Application No. 10/660,005 Docket No. P06673US0-HUS5193 Reply to Final Office Action of October 21, 2004

Amendments to the Drawings:

REMARKS/ARGUMENTS

Fig. 1 amen Ded

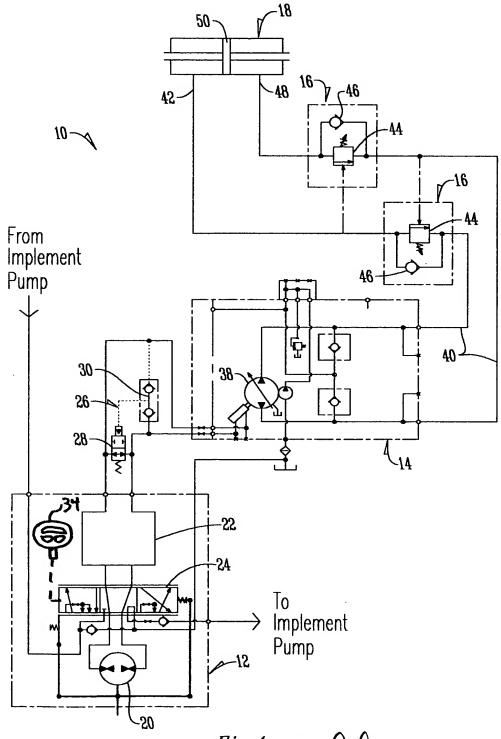
The attached sheet of drawings includes changes to Fig. 1. This sheet, which includes Fig. 1, replaces the original sheet. In Fig. 1, previously omitted element 34 has been added.

The Examiner has maintained his objections to the drawings under 35 C.F.R. 1.83(a) as not showing every feature of the invention specified in the claims. Specifically, the Examiner has maintained his objection that the "steering element" in claim 1 and "steering wheel" of claim 5 are not shown in the drawings.

Previously, the Applicant argued that item 34 shown in Fig. 2 demonstrated the steering element claimed. In response, the Examiner has argued that item 34 shown in Fig. 2 is not the steering element recited in claim 1 which is "a hydraulic steering unit including a steering element for receiving steering input from an operator", where the hydraulic unit is item 12 in the specification and shown only in Fig. 1, and not in Fig. 2.

Accordingly, Applicant has amended Fig. 1 to include steering wheel 34. This Amendment is fully supported by the original disclosure of both claims 1 and 5, as well as the specification at page 5, lines 20-23, reading:

Accordingly, Applicant submits that no new matter has been introduced, and the amended Fig. 1 now provides for the "steering element" and the "steering wheel" claimed in claims 1 and 5, respectively.
